# 1001 BROADWAY

CITY OF SEATTLE DESIGN REVIEW

RECOMMENDATION MEETING #2

DPD PROJECT #3019050

MADISON STREET ELEVATION UPDATES

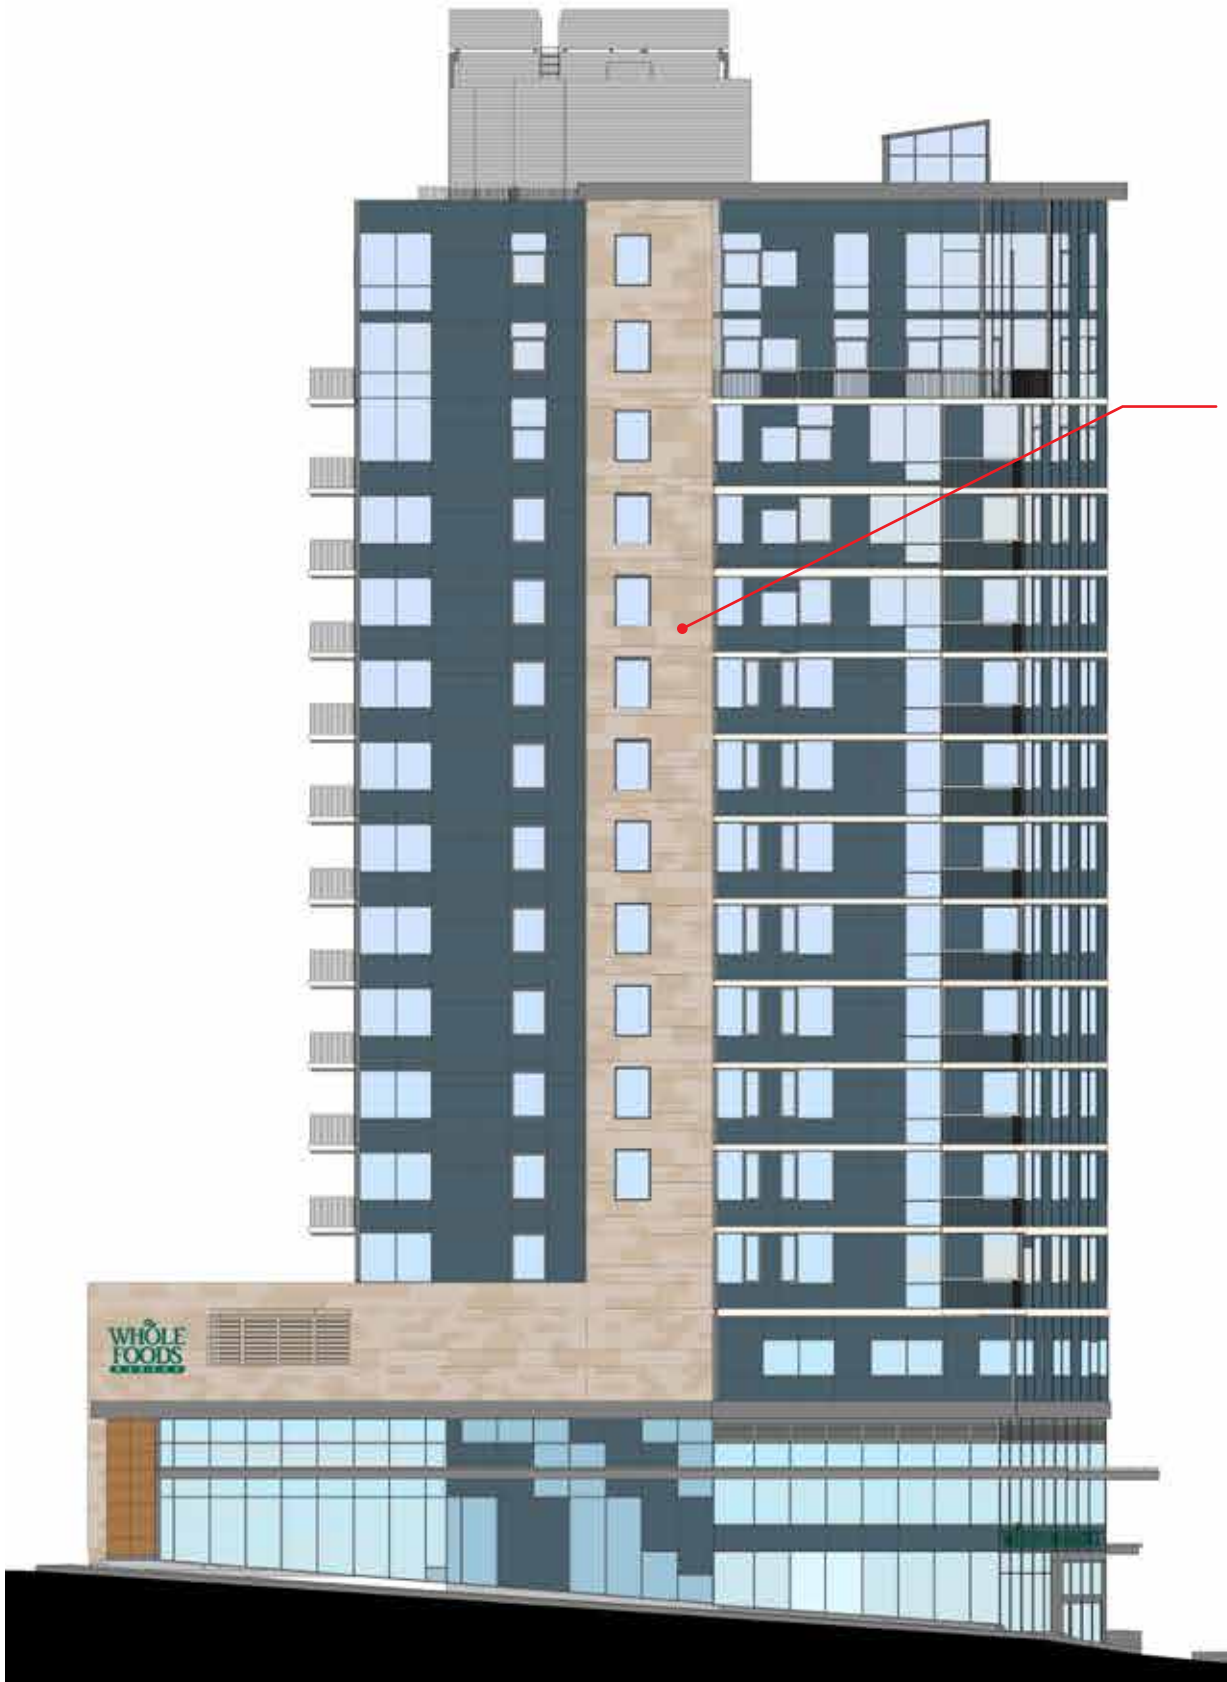
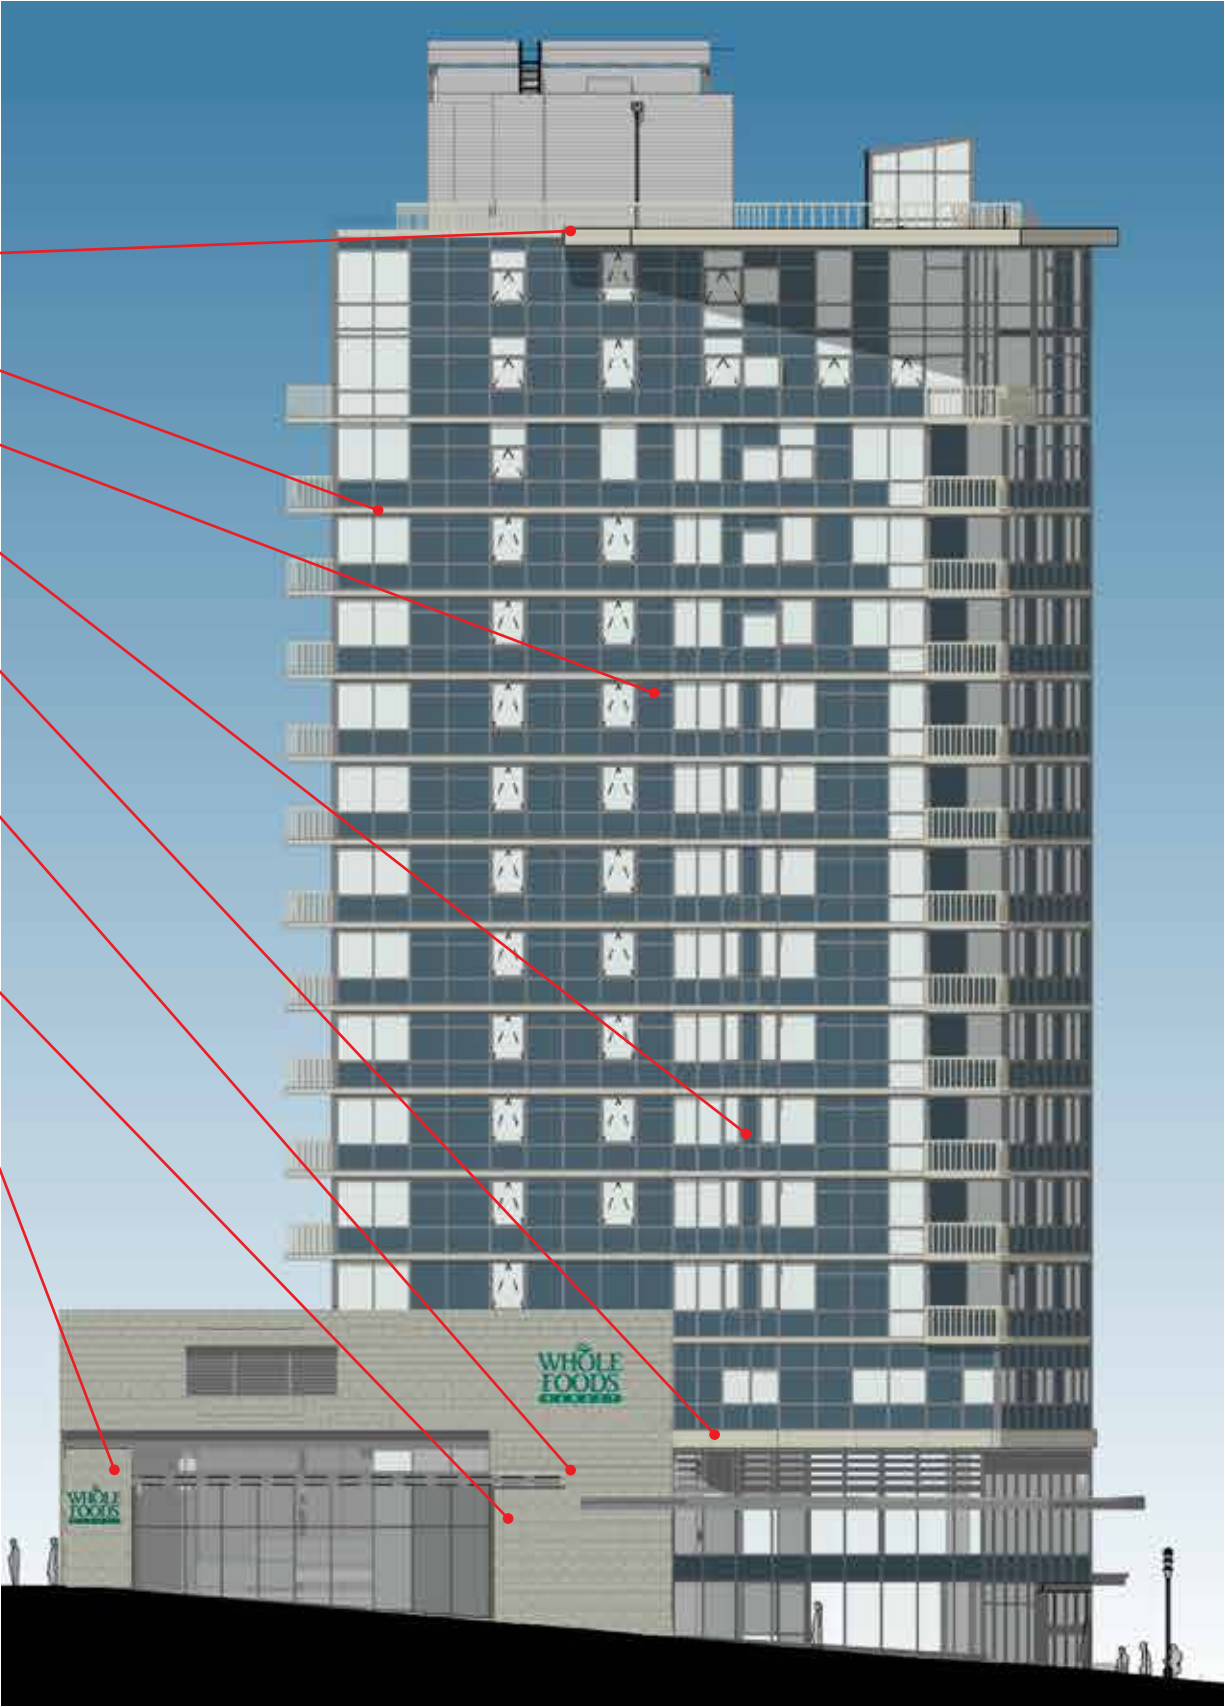
The revised massing proposal incorporates the articulation of the Early Design Guidance Massing Scheme C but lacks Massing Scheme B's strong street wall along Madison Street. The Board noted that the building design should treat Madison as a primary façade and not the side of the structure.

- a) The Board noted the stone material application at the second level continuing to the roof unsuccessfully bifurcates the façade (CS2-A-2, DC2-A, DC2-B).
- b) The Board recommended that the building massing, articulation and material treatment be resolved to treat Madison as a primary façade unifying the structure from ground level to the roof (CS2-A-2, DC2-A, DC2-B).
- c) The Board noted that the revised massing could involve exploring alternative roof lines CS2-A-2, DC2-A, DC2-B).
- d) The Board recommended the 2nd commercial entry on Madison should be developed as a 2nd primary entry (PL3-A, PL3-C).

Revised parapet/roof overhang fascia color to match the titanium colored accent bands on the face of the facade

Titanium accent bands at each floor have been extended to west end of the facade

Deleted stone at residential levels

Provided additional chamfer to unify facade - see page 6 for better view for this revision

Revised color of lower fascia to match titanium bands on face and roof

Stepped canopy shape to tie in better with shape of building above - see page 7 for further information

Returned stone to sidewalk to emphasize the second level entrance and to unify this facade with stone treatment on Harvard and Spring elevations

Revised second level entry wall to stone to help frame entrance and unify similar approach on the Spring Street elevation

HARVARD FACADE VIEW

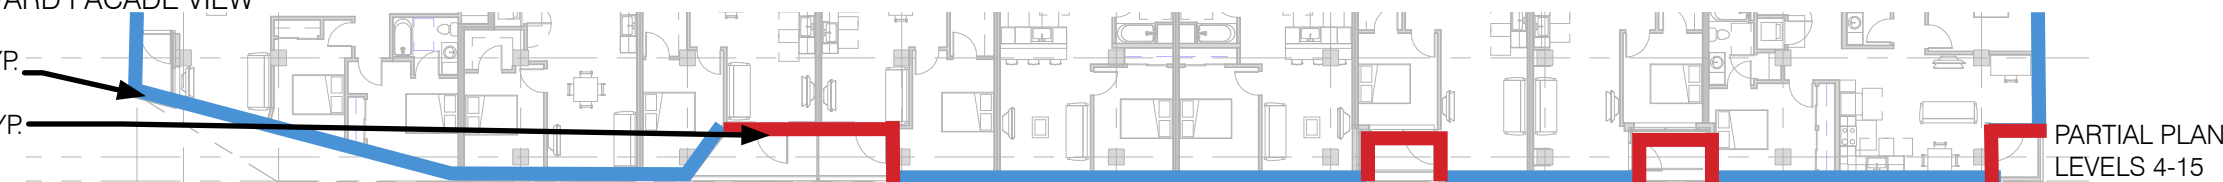
The Board applauded the highly transparent material application but questioned the material color choice. The Board noted the majority of the building is composed of blue transparent and spandrel glass. The color selection detracts from massing moves to break down the building scale of the Harvard Avenue façade. The Board observed that the light spandrel glass in shadow would be a similar color to the dark glass making the modulation on the Harvard Avenue facade less apparent.

- a) The Board recommended a subtler color palette to unify each of the facades, including Madison Street, while accentuating the modulation on the Harvard Avenue and reinforcing the articulation of each façade (DC2-A, DC2-B, DC2-C, DC2-D).
- b) The Board agreed that the color palette should be drawn from local neighborhood context (DC4-A).

Light blue spandrel revised to light grey to emphasize residential bay modulation and to provide more variety in color palette

Removed balconies to accentuate projecting bays

Open railing system helps accentuate the modulated/projecting glass bays

Window color changed to match lighter retail glazing and increase contrast between spandrel colors

Light gray/beige stone

# ALLEY TRASH/TRUCK DIAGRAM

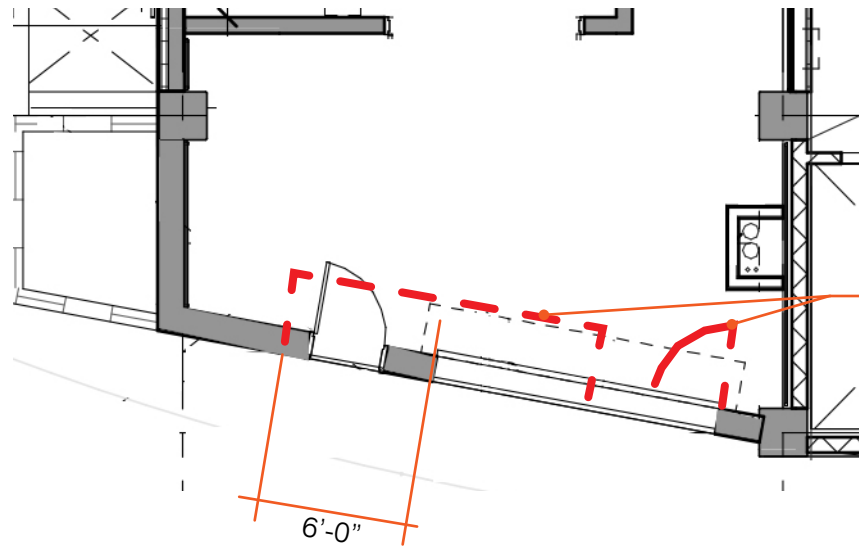
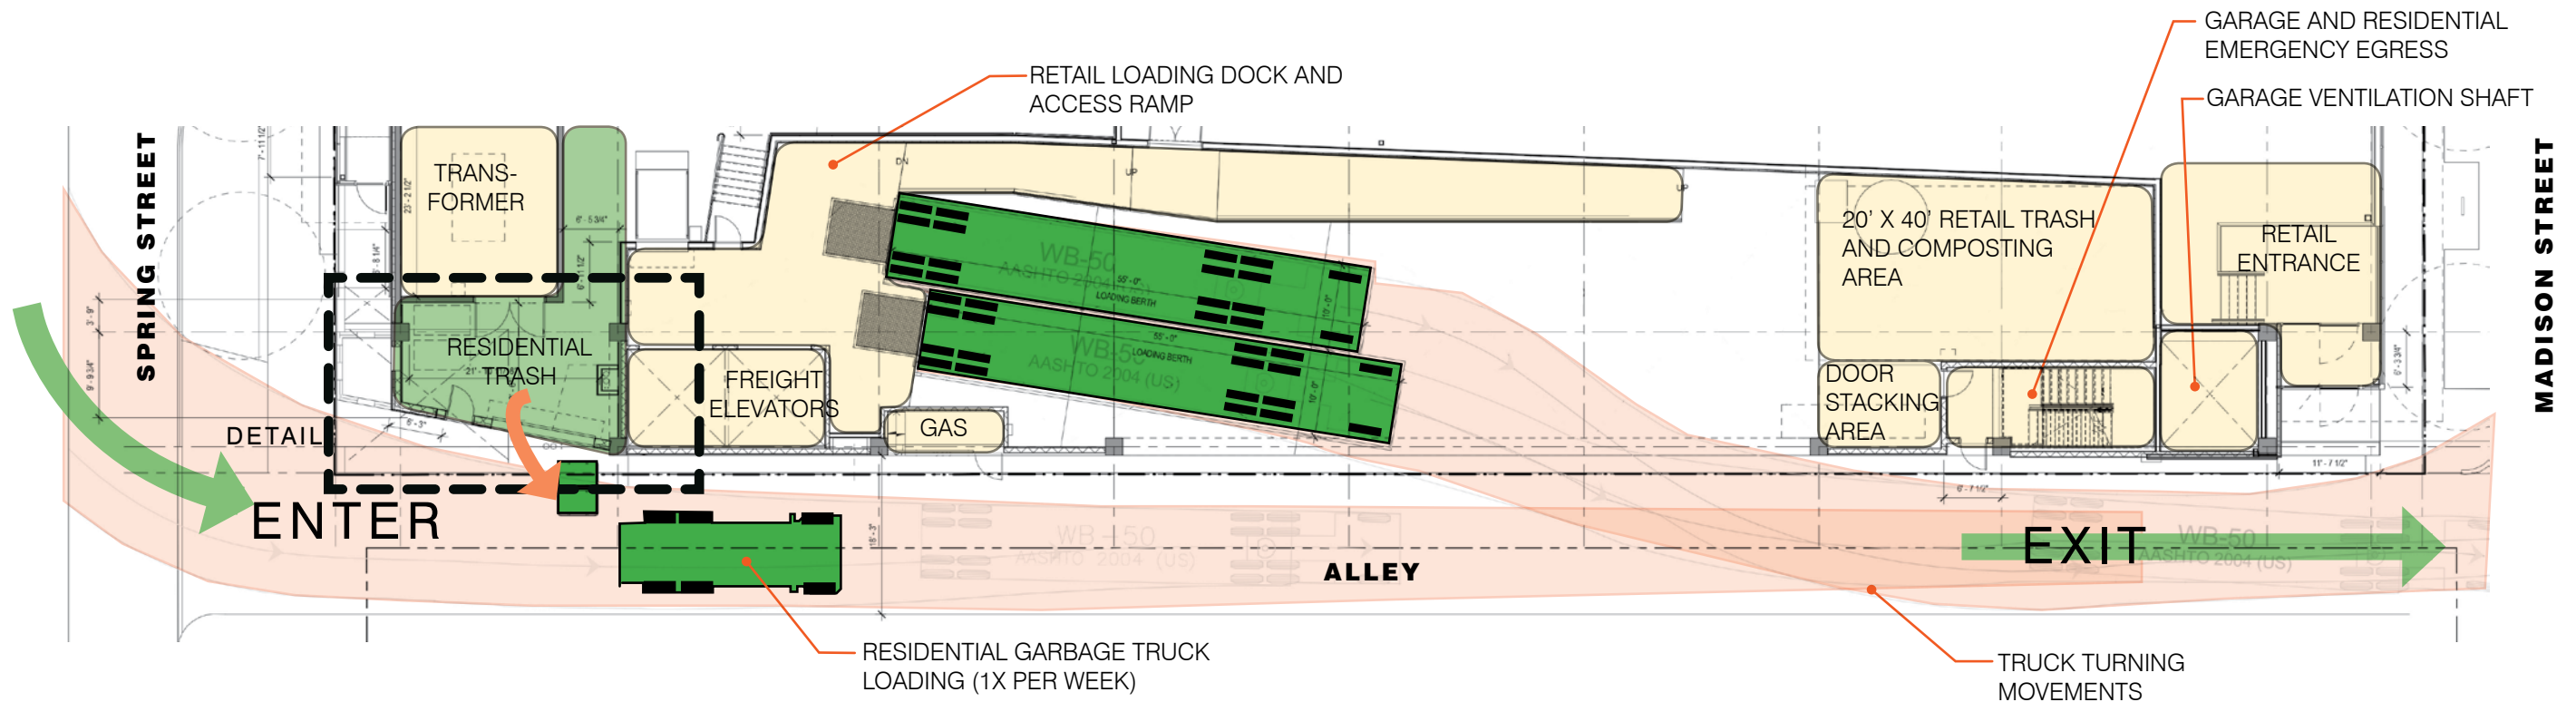
- a) The Board recommended that the residential trash storage be relocated so it is not along the street facing façade (DC1-C4).
- b) The Board questioned whether the bike room at the corner of Spring Street and Harvard Street would successfully activate the corner. The Board recommended that the space be designed to include an active use such as retail (PL2-B, PL3-C).

- Roll-up door moved 6 feet further away from Spring Street
- Previous location of roll-up and man-doors
